CITY OF PORTSMOUTH, NEW HAMPSHIRE

ADDENDUM NO. 2

PRIMARY CLARIFIER AND GRAVITY THICKENER REPLACEMENT

BID NO. 03-15

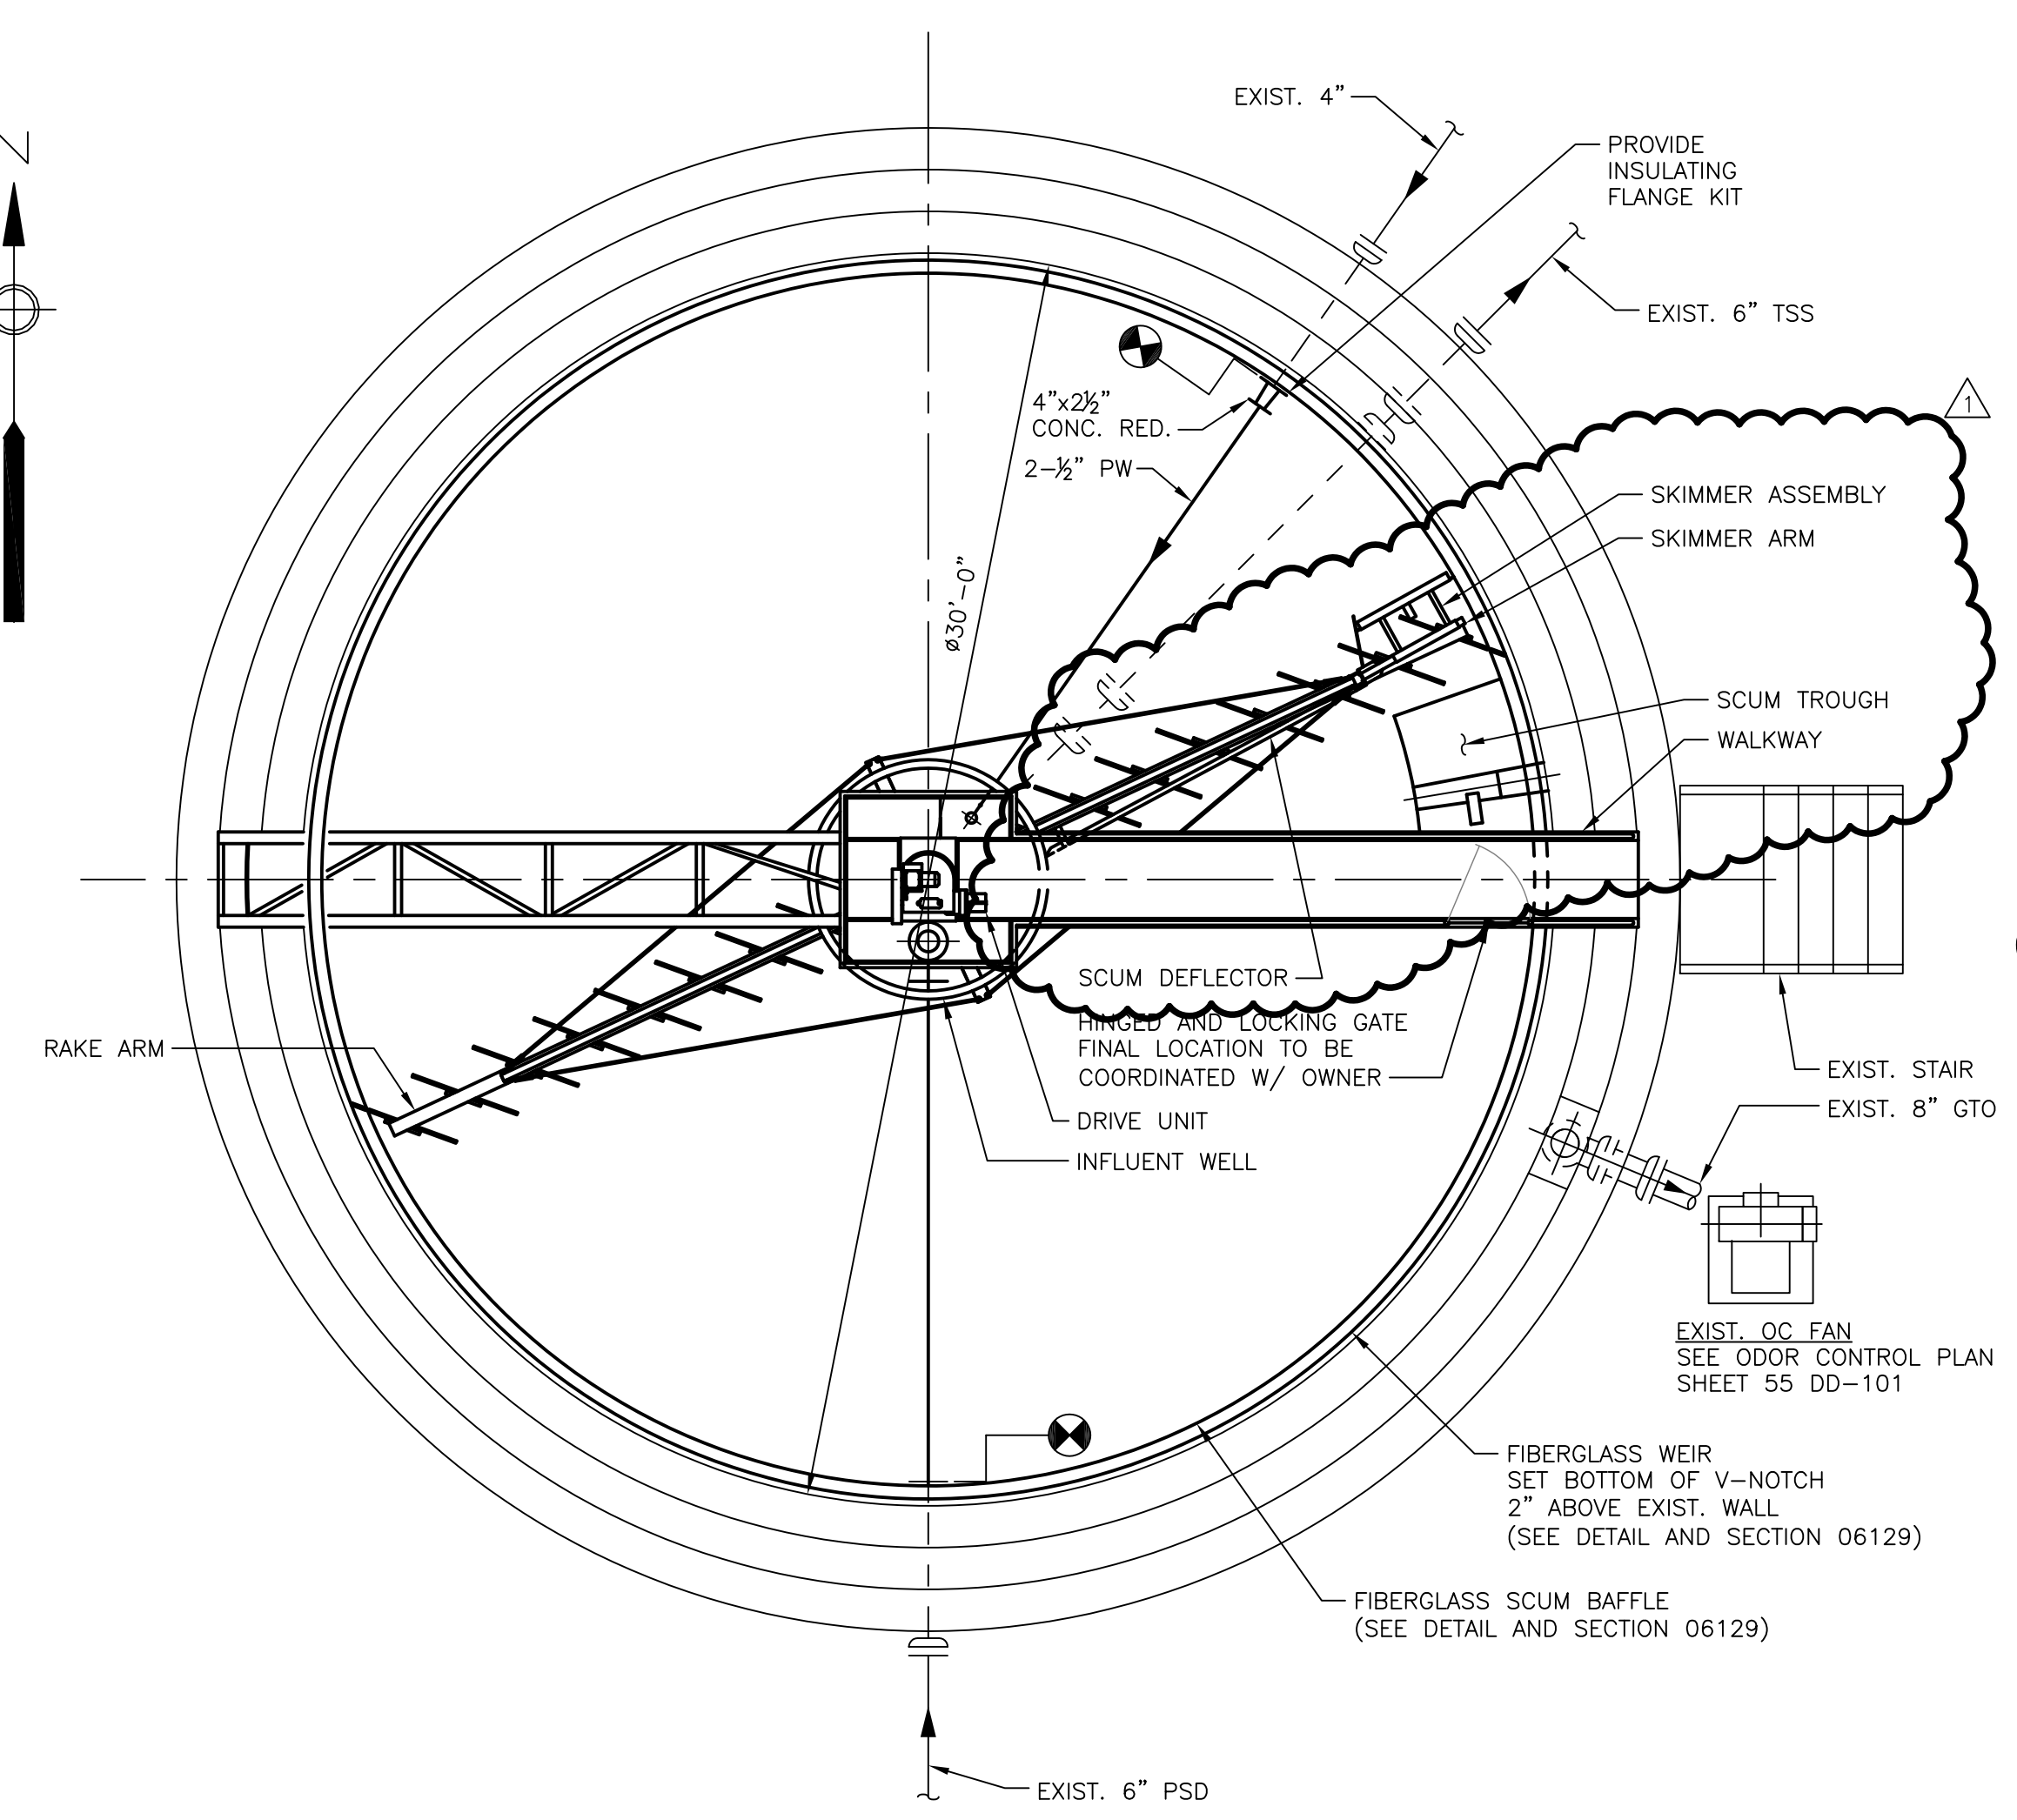
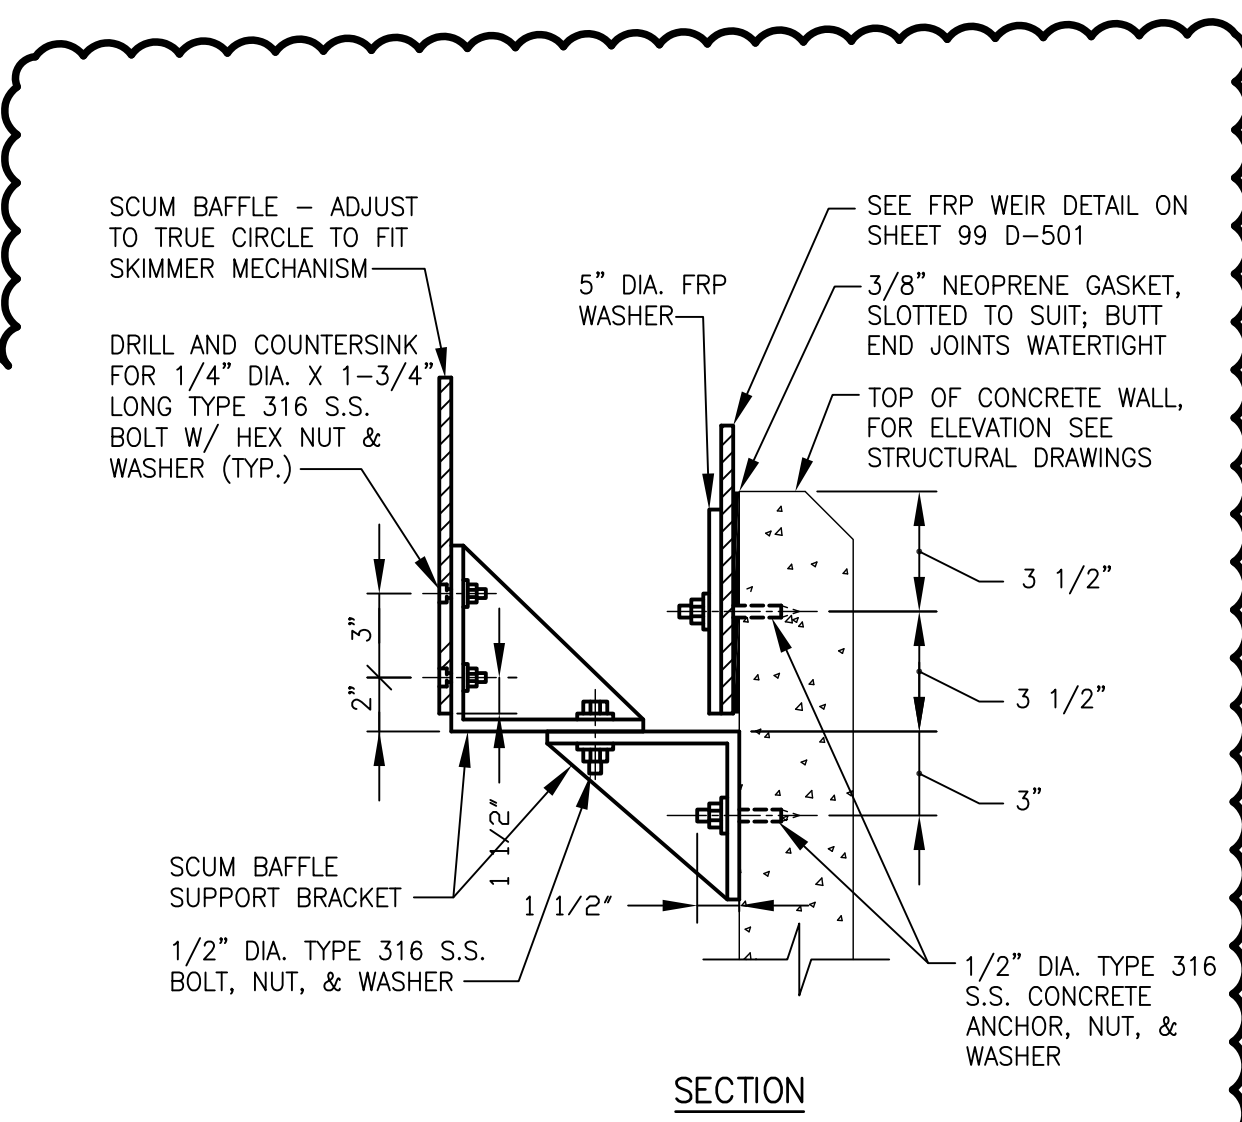
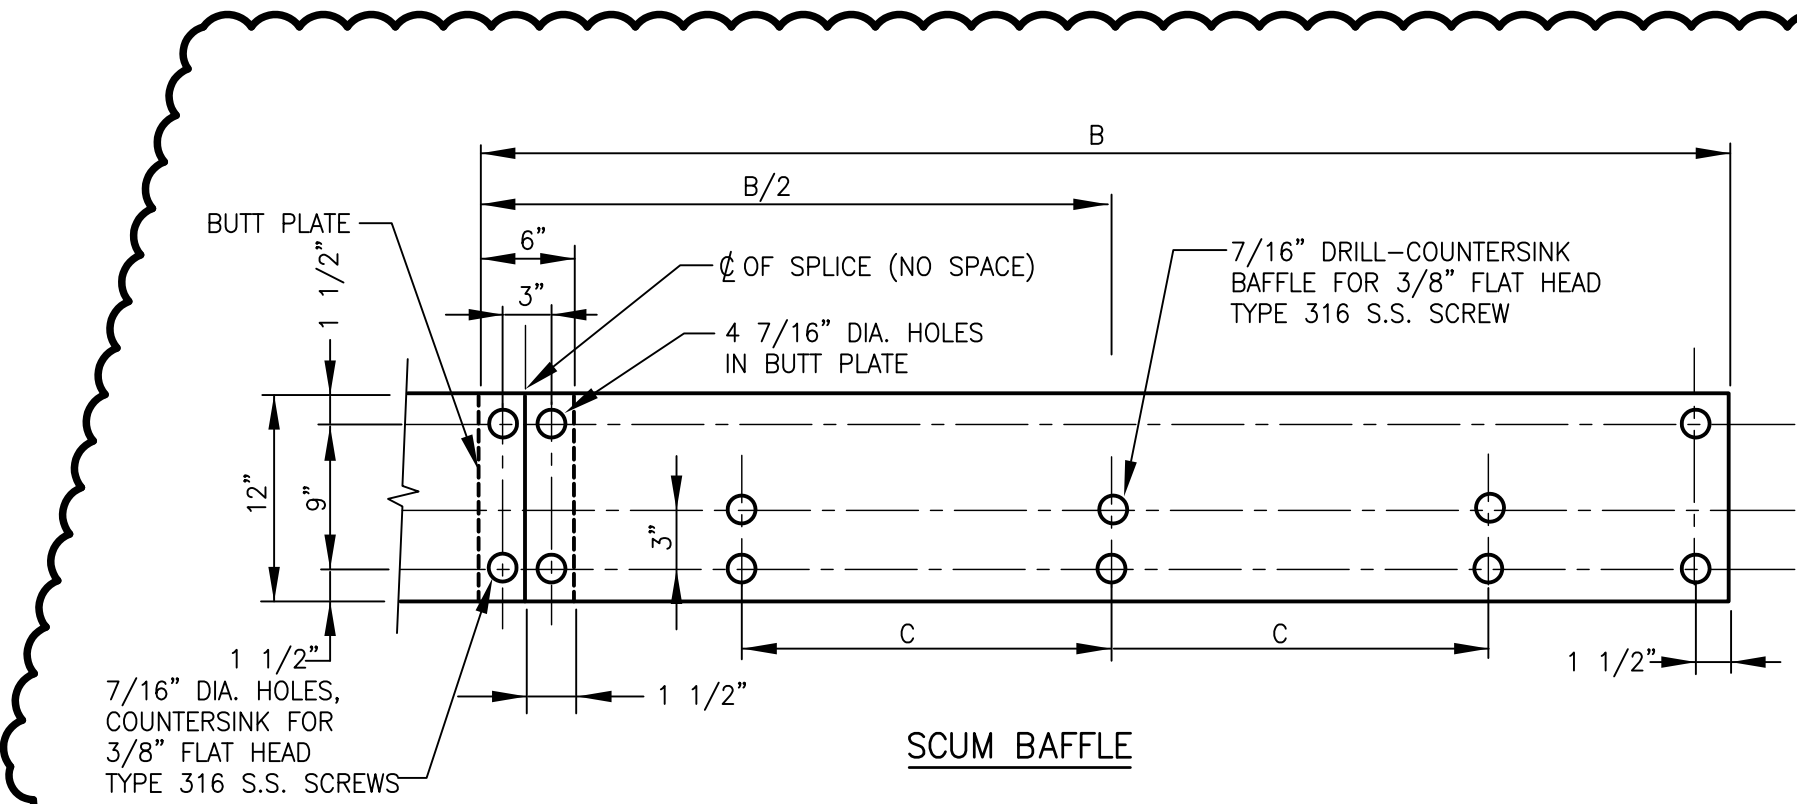
- 1. Delete Sheet No. 55 D-101 and replace it with the attached Sheet No. 55 D-101 dated July 14, 2014.

- NOTES:**
- SEE NOTE ON SHEET 55 DD-101 REGARDING REMOVAL OF EXISTING THICKENER DOME.
 - PROVIDE A SCUM SKIMMER, SCUM TROUGH, FIBERGLASS SCUM BAFFLE, 316 S.S. FASTENERS AND ANCHORS. TURN OVER TO THE OWNER IN ACCORDANCE WITH MANUFACTURER'S LONG TERM STORAGE REQUIREMENTS. THE SCUM SKIMMING SYSTEM TO BE INSTALLED UNDER BID PACKAGE 2.
